CITY OF DE PERE

ADDENDUM NO. 1
PROJECT 22-11
2022 UTILITY AND STREET CONSTRUCTION WATERVIEW HEIGHTS FIFTH ADDITION

CHANGES TO PROJECT BID DOCUMENTS:

CHANGES TO PLANS:

SHEET NO. **63R**

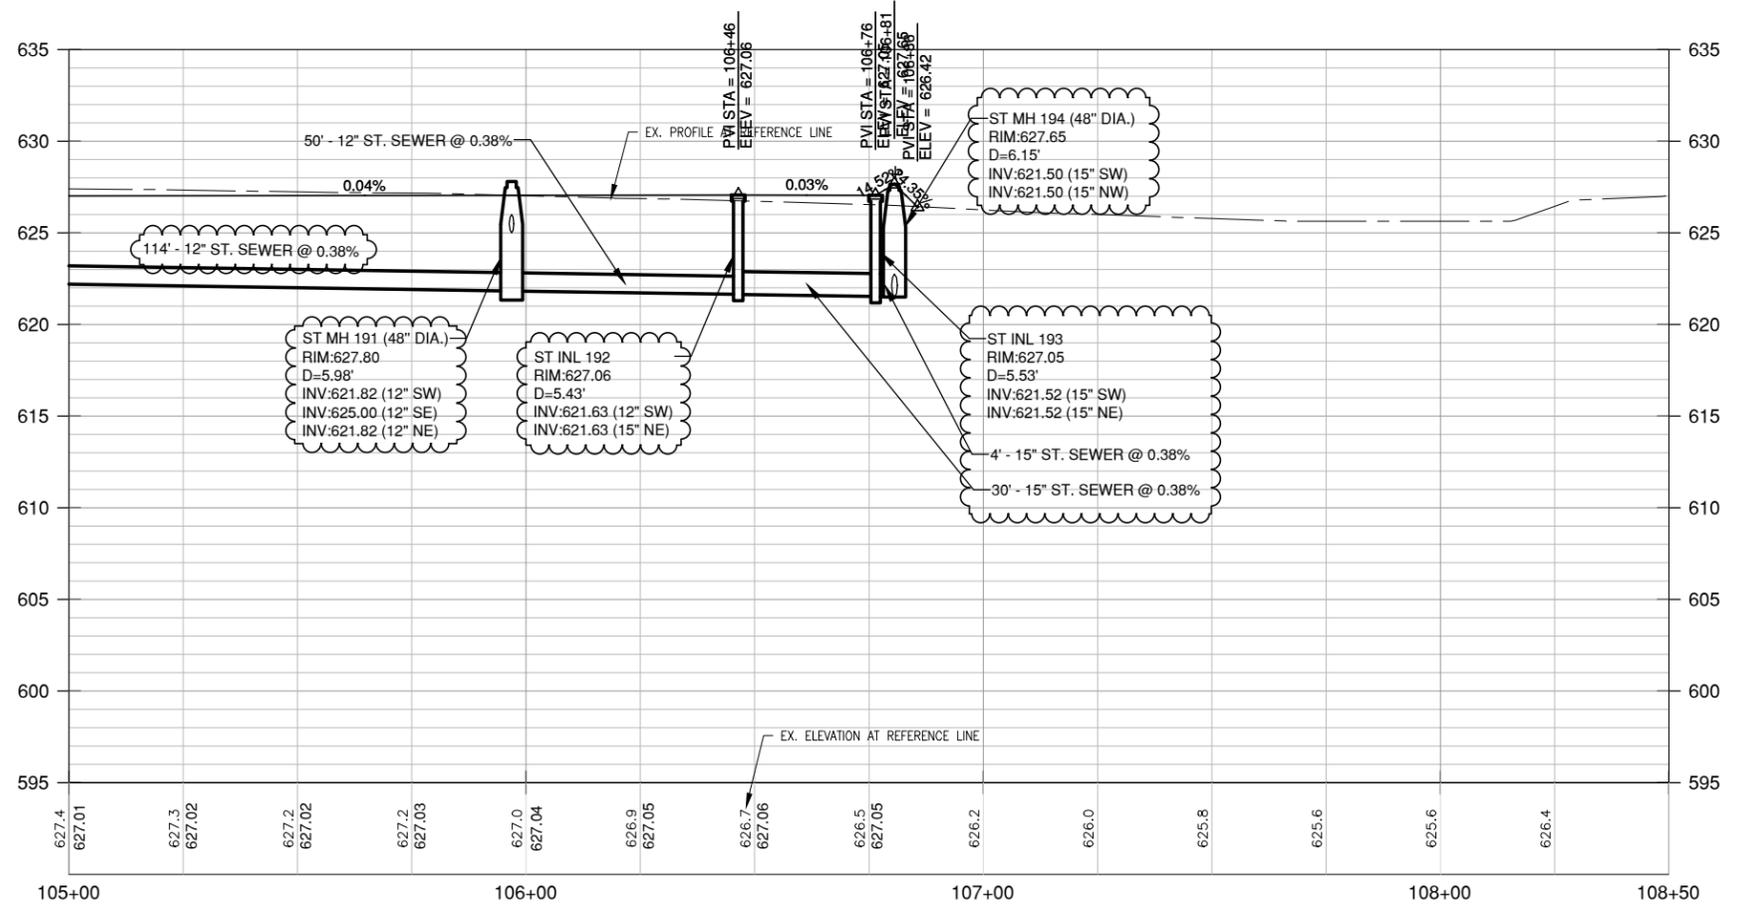
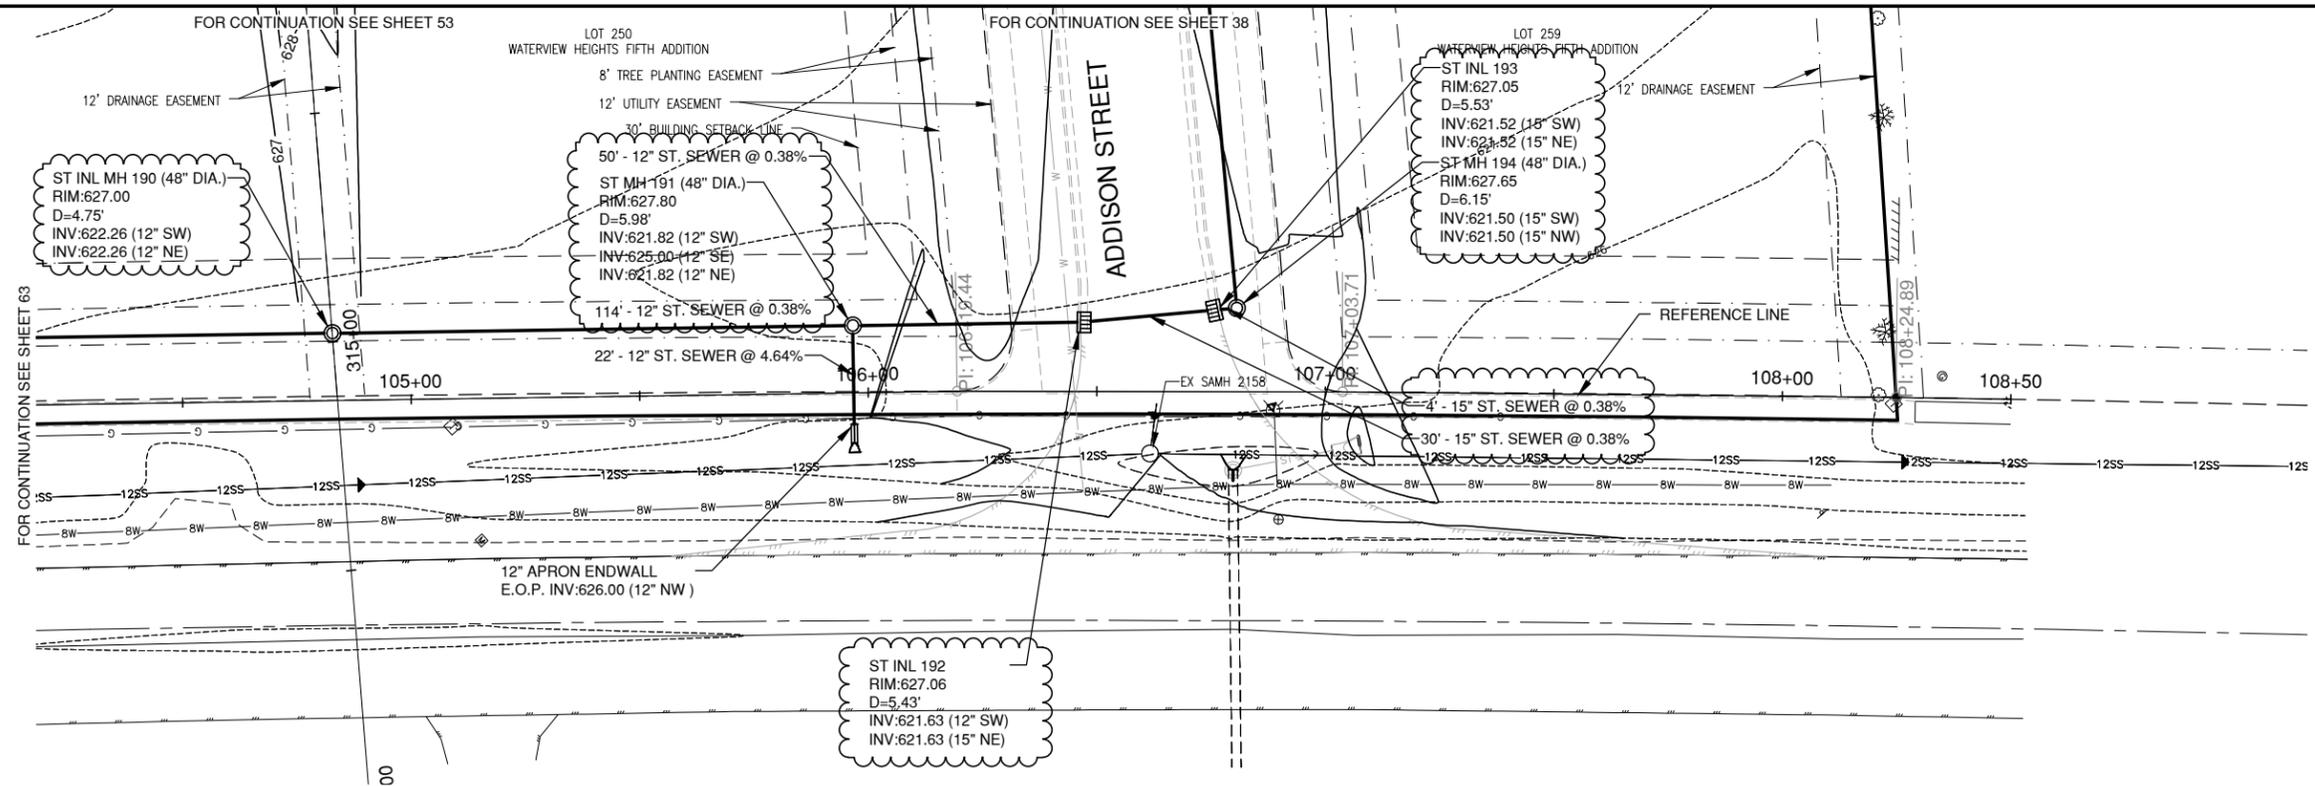
NO.	DATE	APPROV.	REVISION	NO.	DATE	APPROV.	REVISION
1	6/28/22	BDR	STORM SEWER ADJUSTMENTS

SHEET NO.
64R

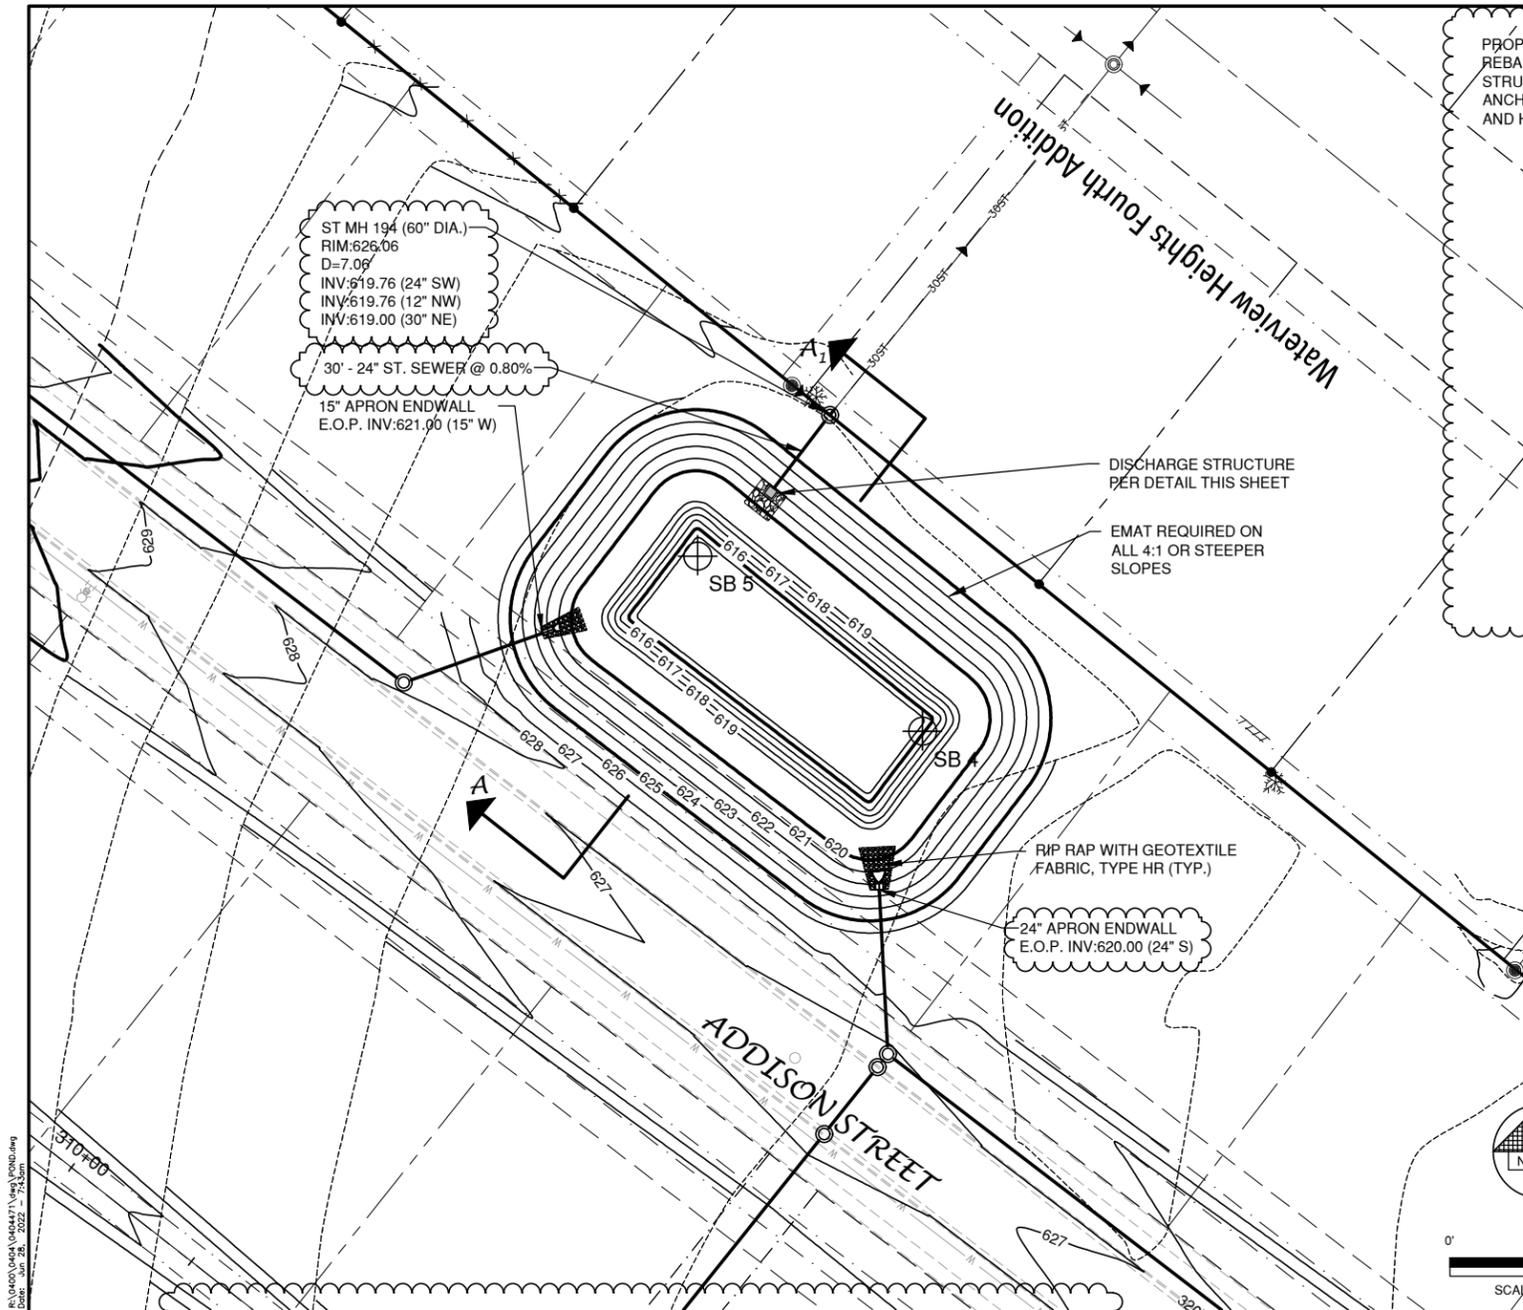
NO.	DATE	APPROV.	REVISION	NO.	DATE	APPROV.	REVISION
1	6/28/22	BDR	STORM SEWER ADJUSTMENTS

SHEET NO.
75R

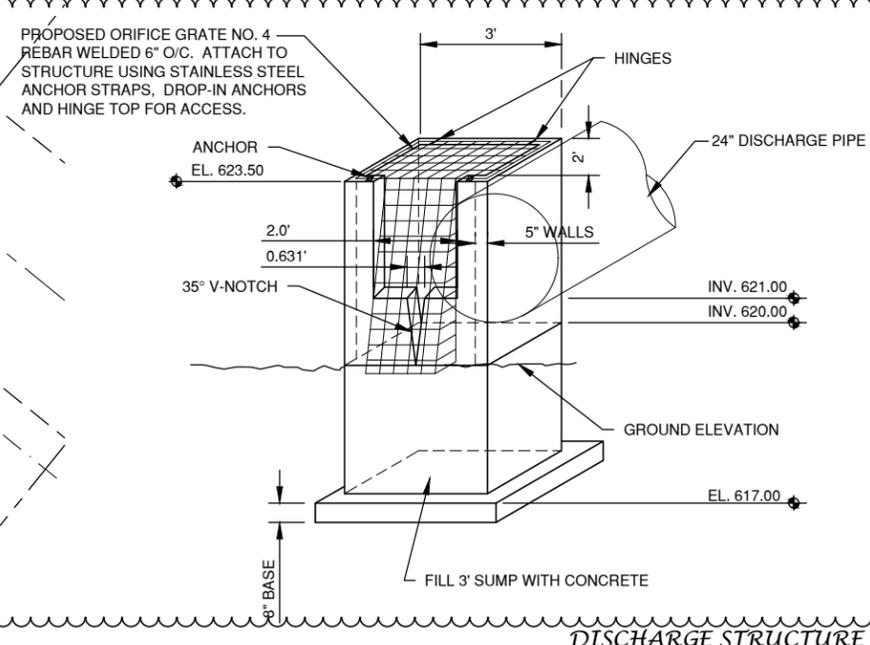
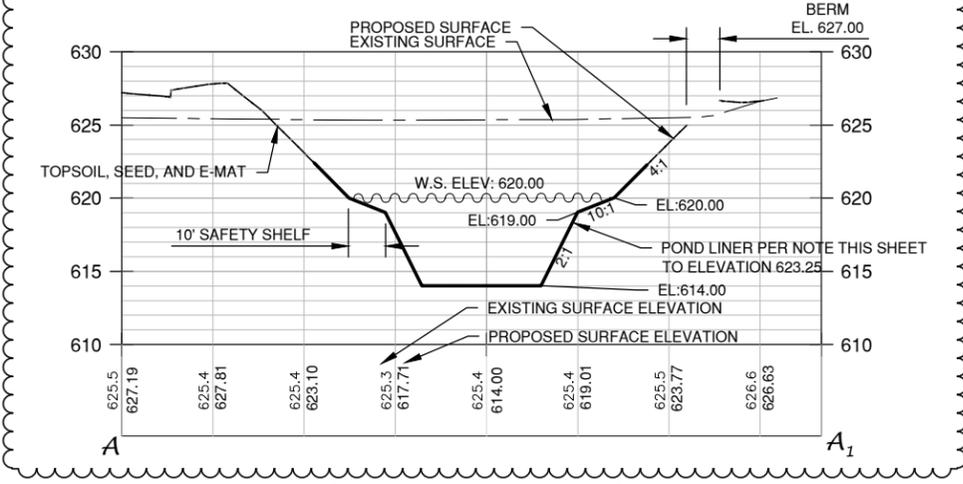
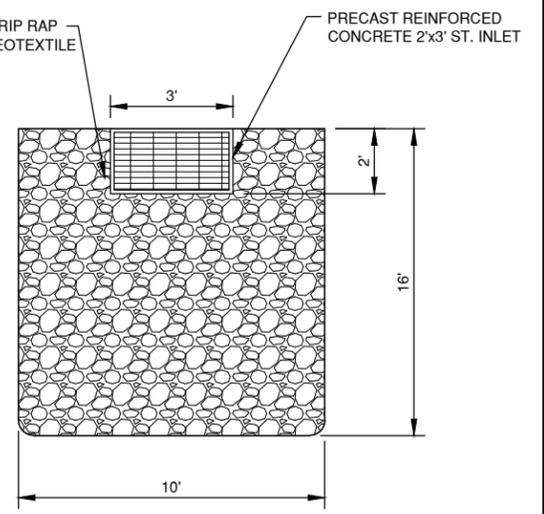
NO.	DATE	APPROV.	REVISION	NO.	DATE	APPROV.	REVISION
1	6/28/22	BDR	STORM SEWER ADJUSTMENTS
